Transbay Transit Center San Francisco, CA CM/GC Contract No. 08-04-CMGC-000 Project No. 30100

BID PACKAGE TG07.3 ADDENDUM #7

DATE: 01/16/2015

MODIFIED DOCUMENTS PER ADDENDUM #7

BASED ON SHEET A1-7502

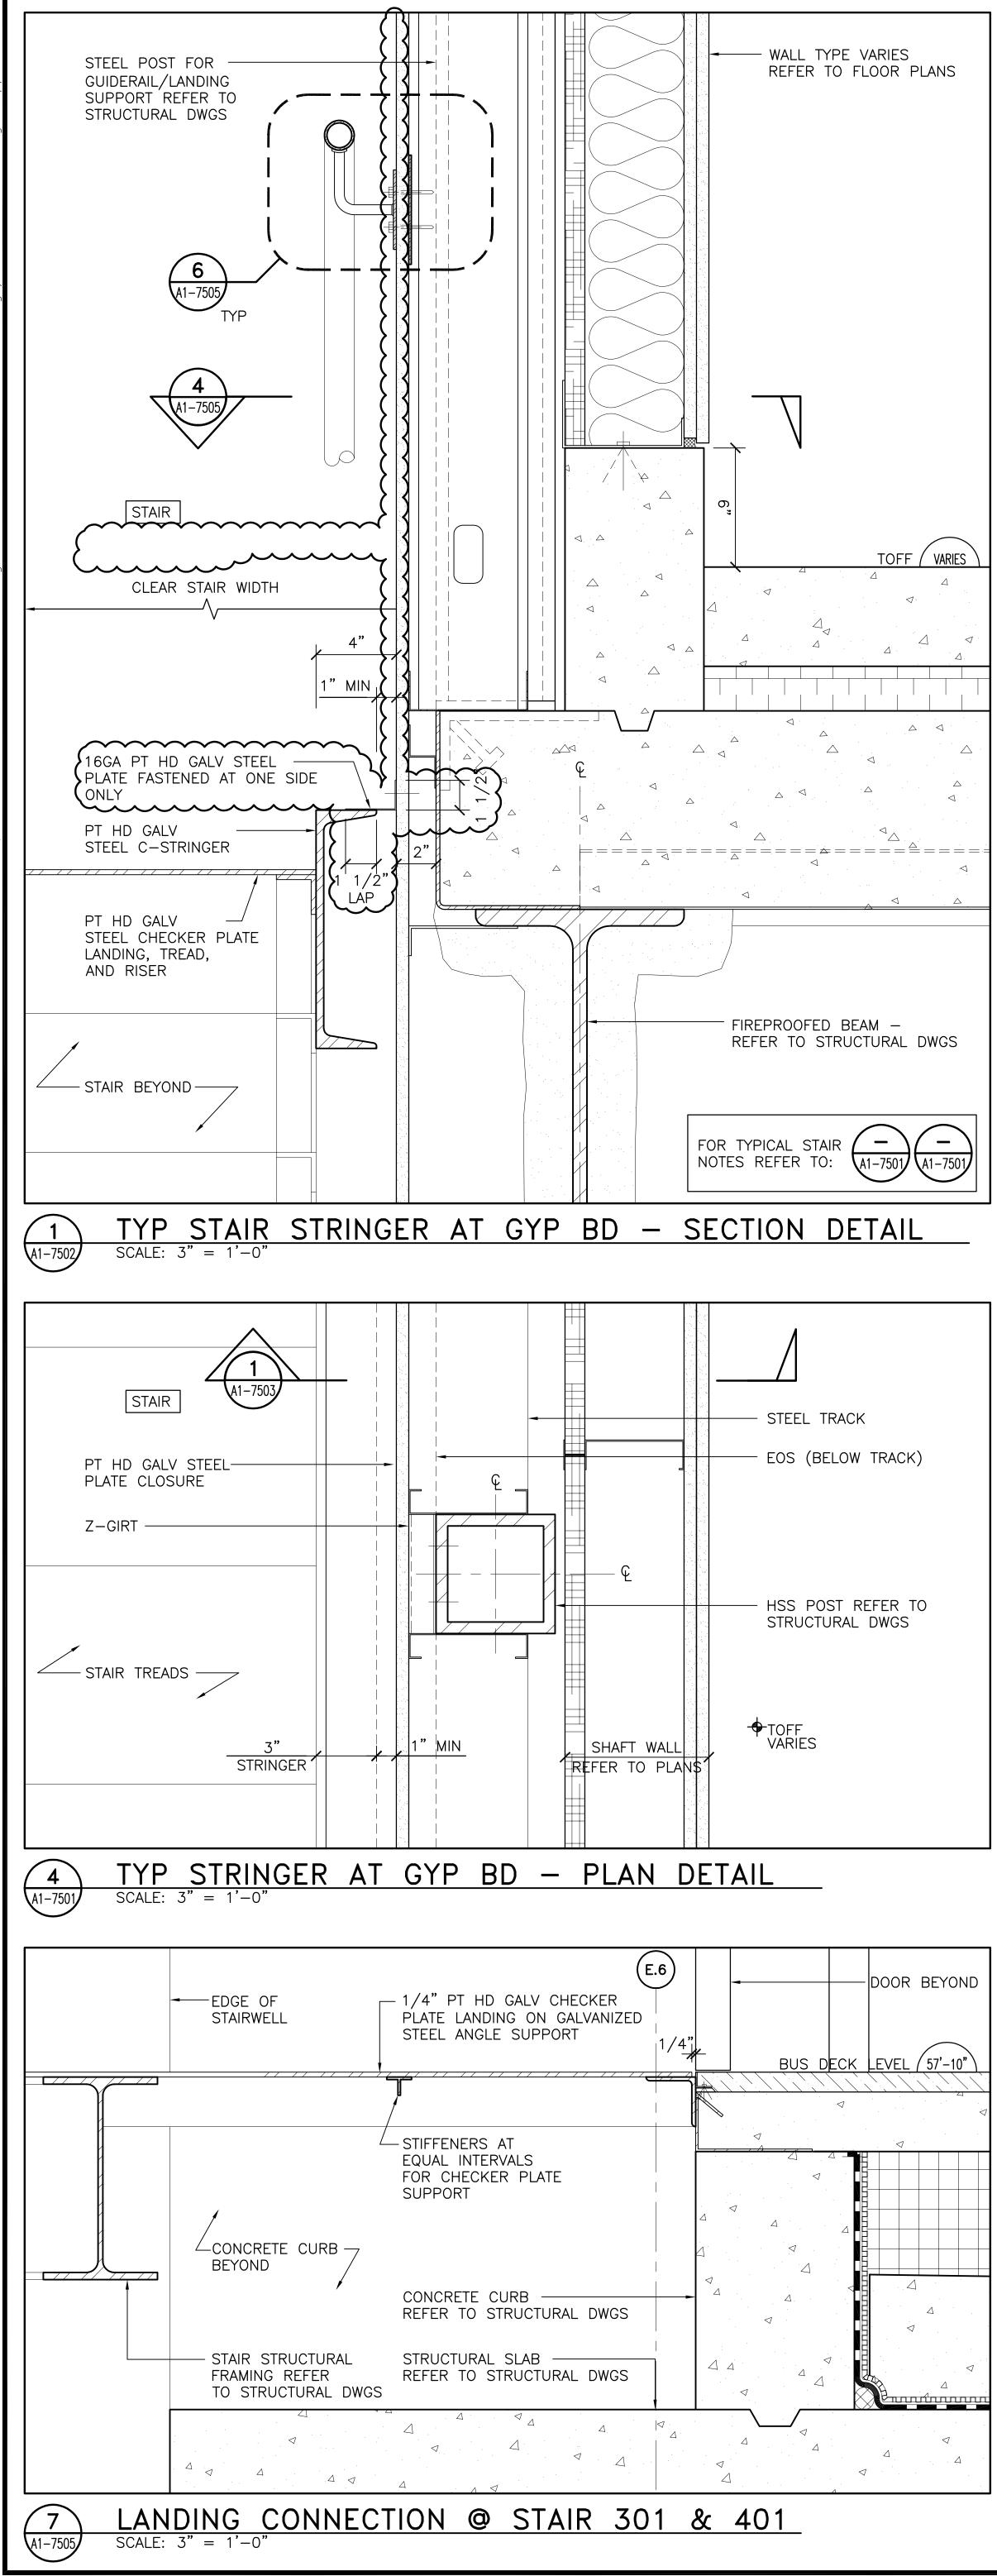
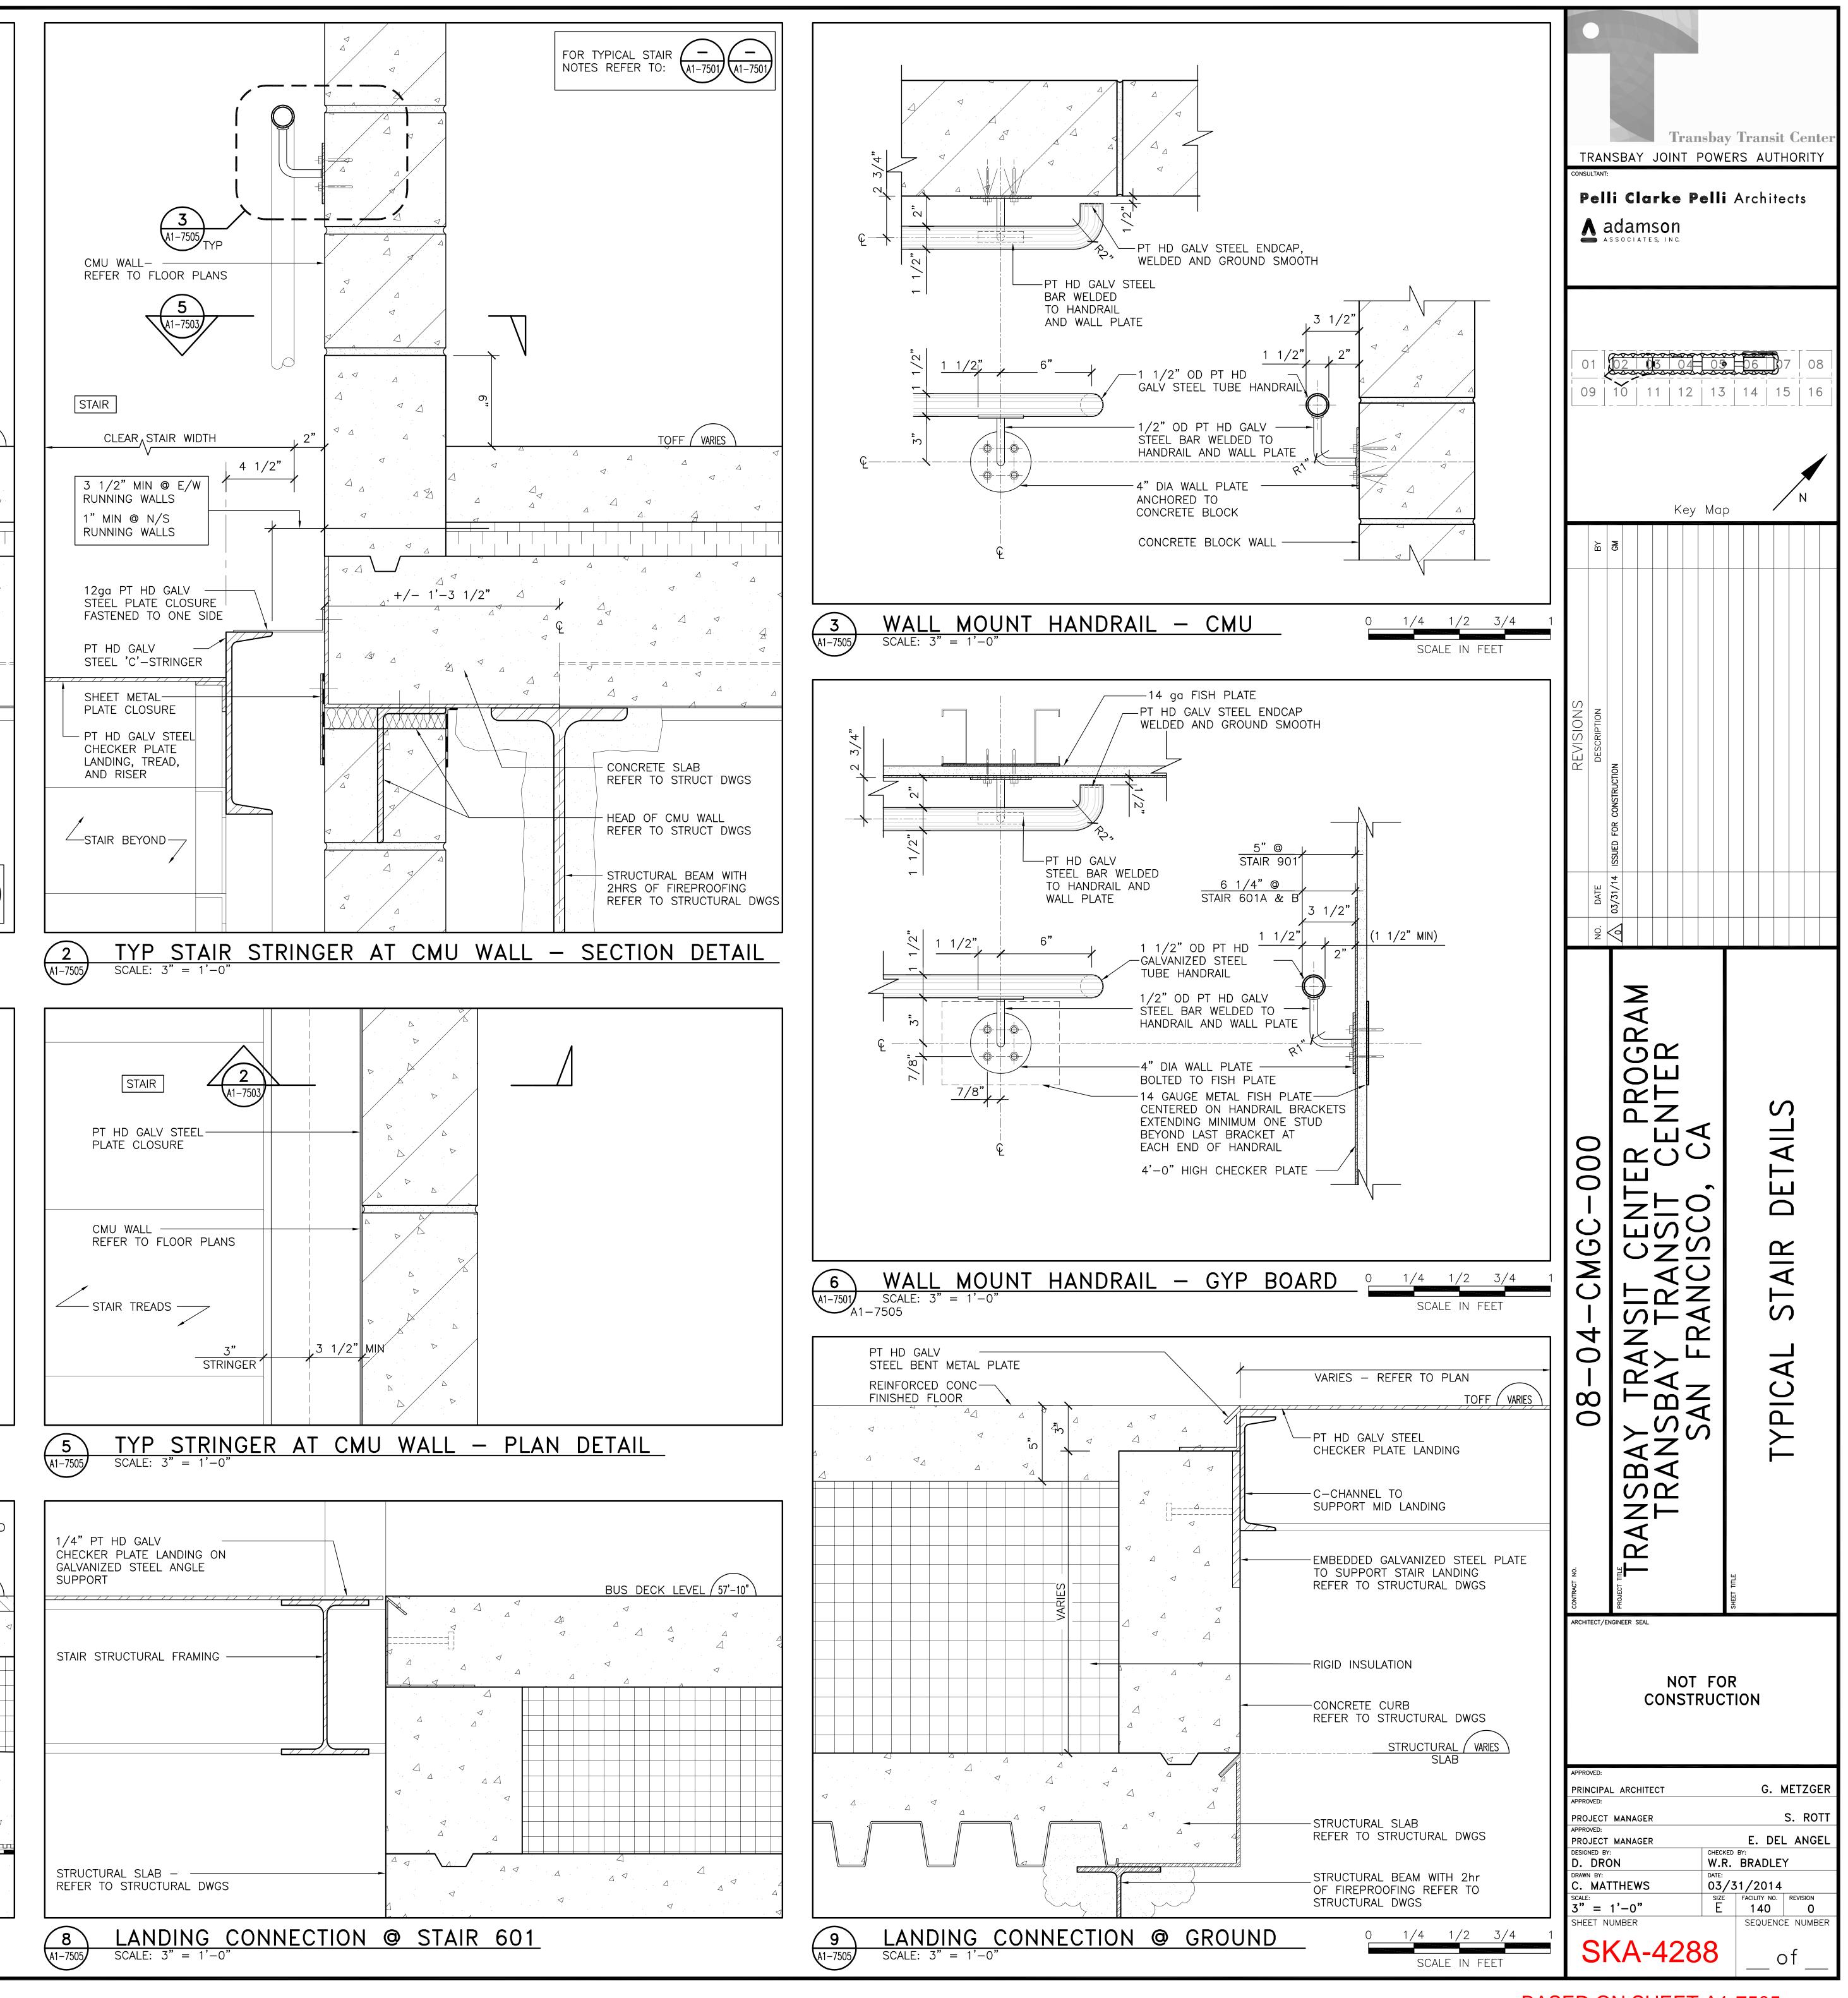
Question No.	Submission Date	Drawing No.	Document/ Spec. No.	Question	Response
TG07.3- 005	9/23/2014	A1-7585		REFERENCE: Detail 8/A1-7585 (ASI 127, dated 9/12/14) Detail 8/A1-7585 of ASI 127 indicates structural for elevator machinery support and elevator machinery support locations are to be verified by elevator consultant. Structural does not identify the elevator machinery support and the location has not been provided. Please provide structural information and location for the elevator machinery support.	Structural information for detail 8/A1-7585 can be found on S1-7101. Final location of the elevator machinery must be coordinated with elevator contractor.
TG07.3- 007	10/7/2014			[Bidder] requests a three-week bid date extension on this project.	Please see TG07.3 Exhibit A, Addendum 4, Section II. – Key Dates for Bidding Process, Package Timeline, for revised package timeline. The revised bid date is Wednesday, November 19, 2014, at 2:00 pm.

BASED ON SHEET A1-7550

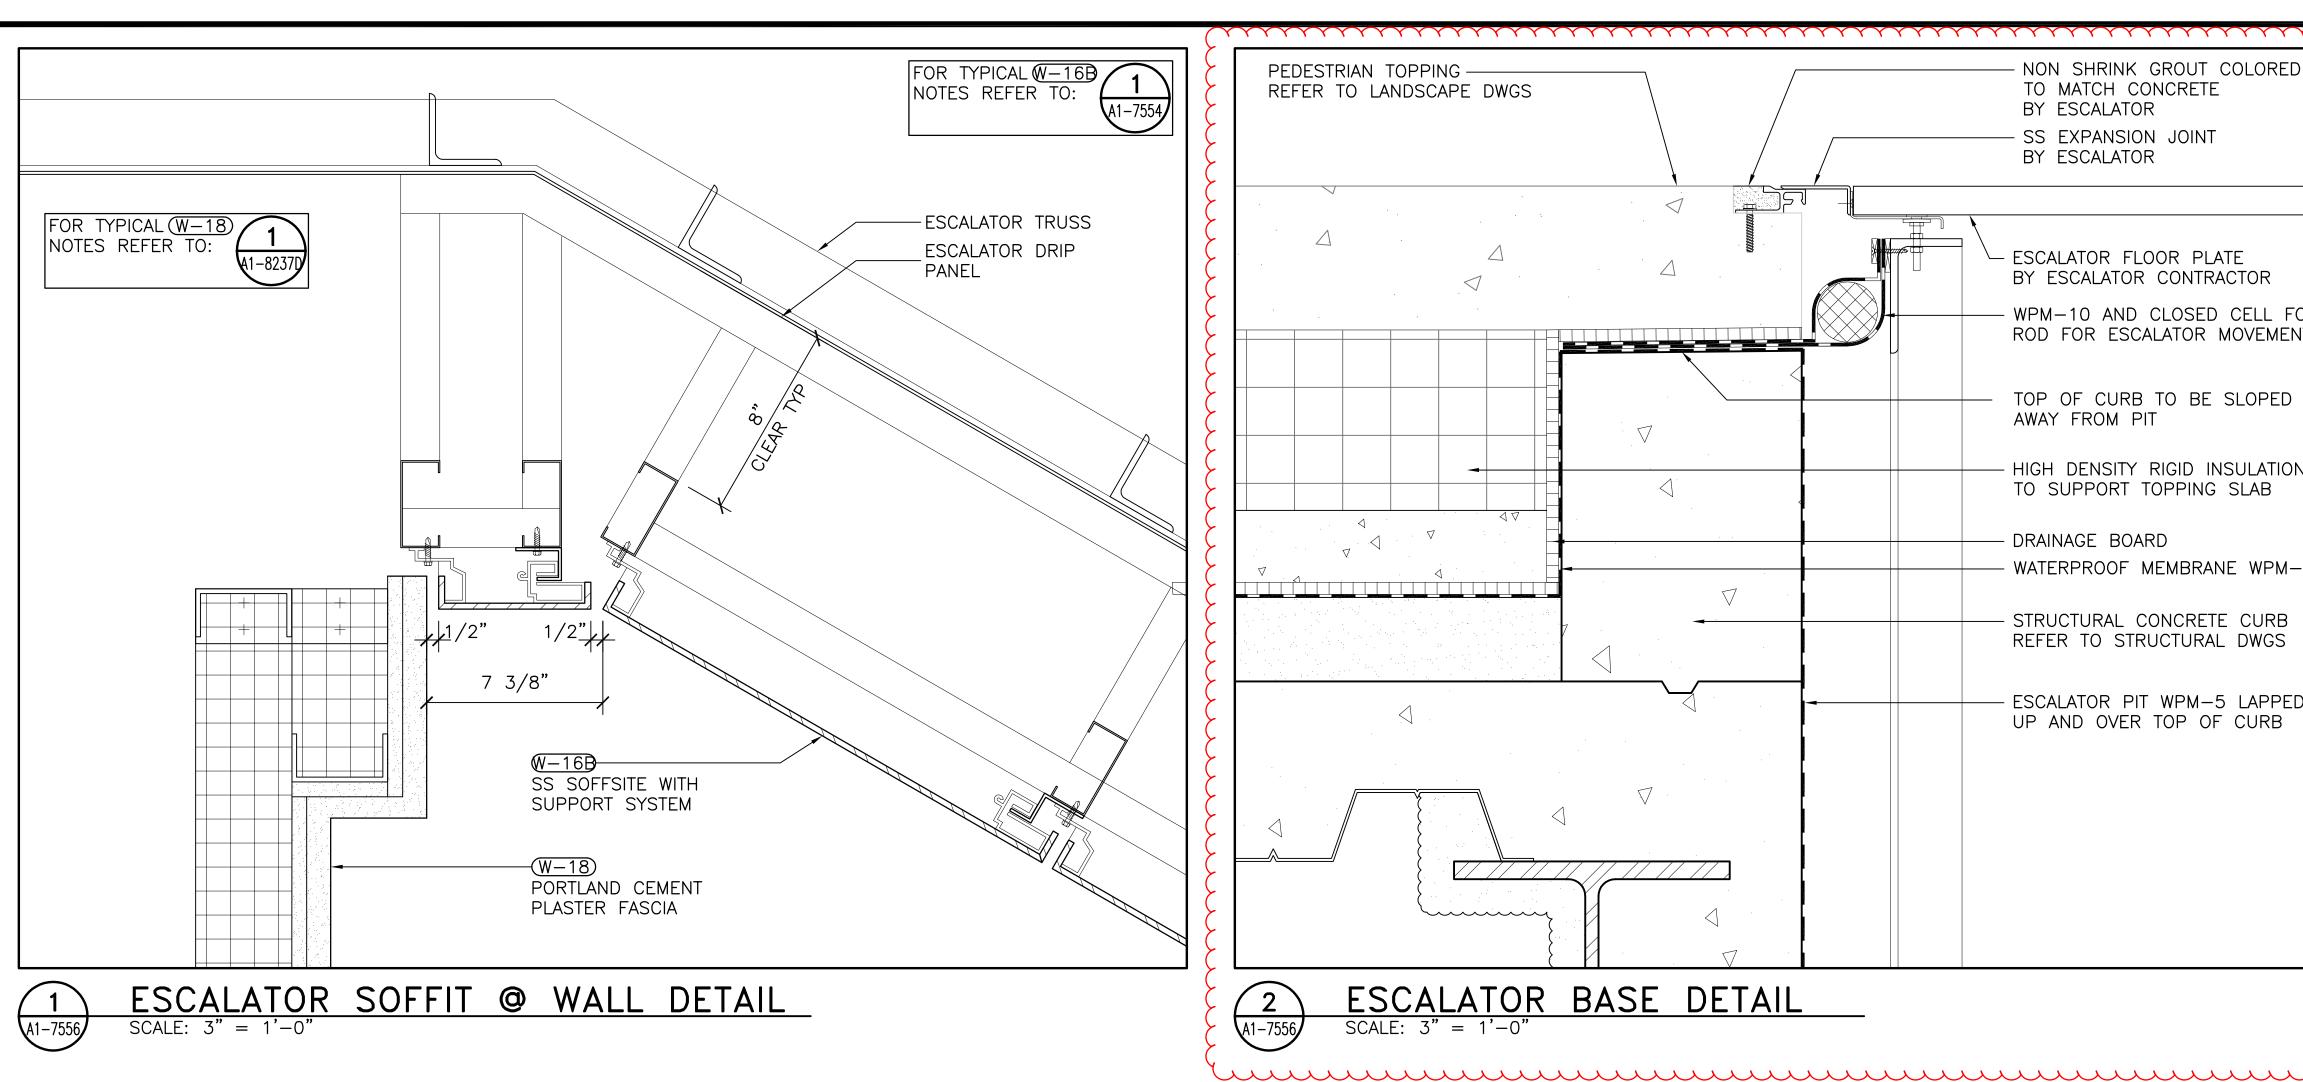
Question No.	Submission Date	Drawing No.	Document/ Spec. No.	Question	Response
TG07.3- 065	10/30/2014	4/A1-7550	05 50 00	Please provide more dimensions for plate and how it will be connected.	Yes, this plate will be used in both pits. The plate is 3/8 inch thick, and has a stepping profile. The step in the plate
				Is it located in both pits?	is below the handrail, 1" before the Escalator landing plate. Location of handrail and landing plate to be confirmed by Escalator contractor. Please refer to attached SKA-4298, SKA-4299, & SKA-4300 for additional information.
TG07.3- 070	10/30/2014	4/A1-7027	05 50 00	Is the chain link fence part of Bid Package TG07.3?	The chain-link fence is included in the work of TG07.3. See the Response to QBD TG07.3 Set 2, Question No. 001.
TG07.3- 071	10/30/2014	All/A1-7026	05 51 00 05 50 00	If so; Please provide clear details and specs. Is this steel part of Bid Package TG07.3?	Steel platform and stairs at the Train Platform Level are not included in the work of TG07.3.

Question No.	Submission Date	Drawing No.	Document/ Spec. No.	Question	Response
TG07.3- 139	11/14/2014	4/A1-7550	05 50 00	Is the "Galvanized Steel Support Angle" by Bid Package TG07.3? If so; Please provide intent and detail of connection.	The galvanized steel support angle directly below the stainless-steel escalator closure panel with support system is not included in the work of TG07.3.
TG07.3- 140	11/14/2014	8/A1-7579	Exhibit A pg. 8 Item #6 05 50 00	Per Exhibit A "CMU wall bracing" is excluded, but on "Scope Drawing" it's highlighted. Is this bracing by Bid Package TG07.3? If so; Please provide locations and details.	Bracing of CMU walls is excluded from the work of TG07.3.
TG07.3- 142	11/14/2014	6/A1-7836	05 50 00	After I hunted this beam down through A1- 7306, A1-7307, S1-2406, 3/S1-7015, 1 and 5/S1-7662, the beam that's on the second level at the grid lines shown is a MF (moment) beam. Is this in bid package TG07.3? (typically this would be by structural steel contractor)	Moment frame steel structural steel is not included in the work of TG07.3. Escalator support steel, where required, is included as part of Exhibit A, Inclusion 16.
